APPLICATION NO.	FILING DATE	FIRST NAMED INVENTOR	ATTORNEY DOCKET NO.	CONFIRMATION NO.
10/732,935	12/10/2003	Brent L. Bristol	H0005435--1180	7284

Office Action Summary

Richard Edgar

FIG. 4

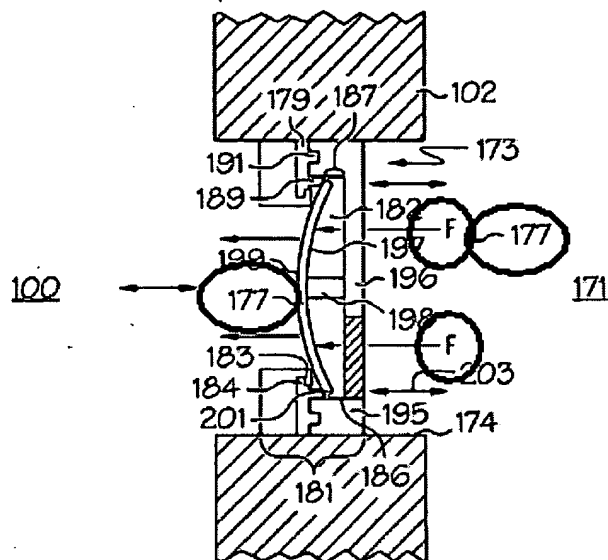
The drawings are objected to as failing to comply with 37 CFR 1.84(p)(4) because reference character "177" has been used to designate different elements (see Fig. 4 annotated on the following page).

The drawings are objected to as failing to comply with 37 CFR 1.84(p)(5) because they include the following reference character(s) not mentioned in the description: "F" and "301" (see Figs. 4 and 5 annotated on the following page).

Corrected drawing sheets in compliance with 37 CFR 1.121(d), or amendment to the specification to add the reference character(s) in the description in compliance with 37 CFR 1.121(b) are required in reply to the Office action to avoid abandonment of the application. Any amended replacement drawing sheet should include all of the figures appearing on the immediate prior version of the sheet, even if only one figure is being amended. Each drawing sheet submitted after the filing date of an application must be labeled in the top margin as either "Replacement Sheet" or "New Sheet" pursuant to 37 CFR 1.121(d). If the changes are not accepted by the examiner, the applicant will be notified and informed of any required corrective action in the next Office action. The objection to the drawings will not be held in abeyance.
